Product Change Notification

113291 - 00

Change Notification #: 113291 - 00
Change Title: Intel® Server System R1304GL4DS9
PCN 113291-00, Product Design
Update the System Rear Panel, add a Mylar
and a Plastic Block
Date of Publication: October 13, 2014

Figure One

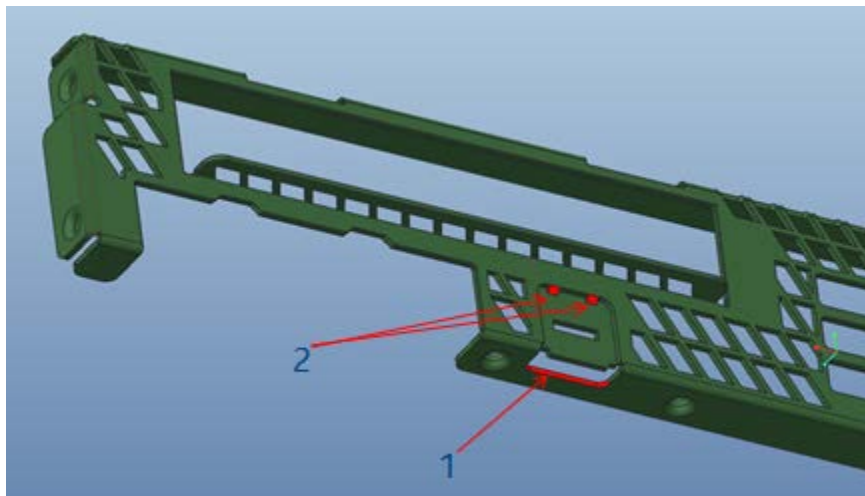
1. Add a connection at the bottom of the RMM4 (Remote Management Module 4) slot to improve structure strength. See item 1 in the Figure One.
2. Update the one big center joint to two smaller joints so that the joints will not conflict with the LAN cable connector latch. See item 2 in the Figure One.

Figure Three

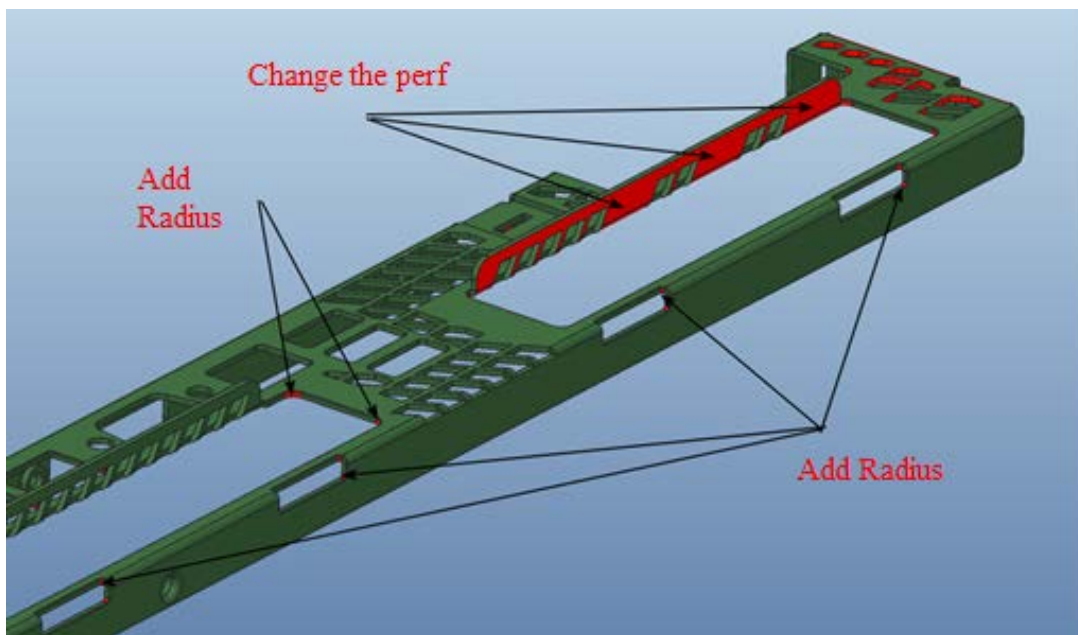
4. Update the perf and add radius to improve structure strength. See the Figure Three and Four.

Figure Five

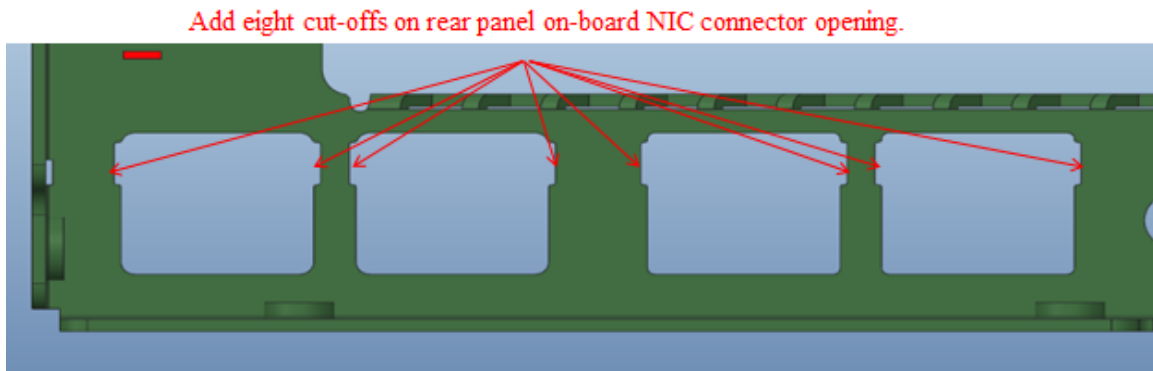
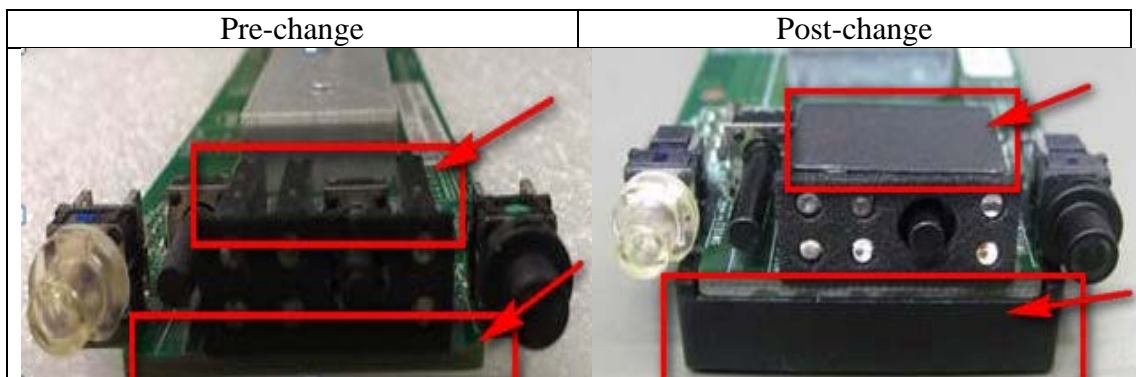
5. Add eight cut-offs around the on-board NIC (Network Interface Controller) openings to improve the LED visibility. See the Figure Five.
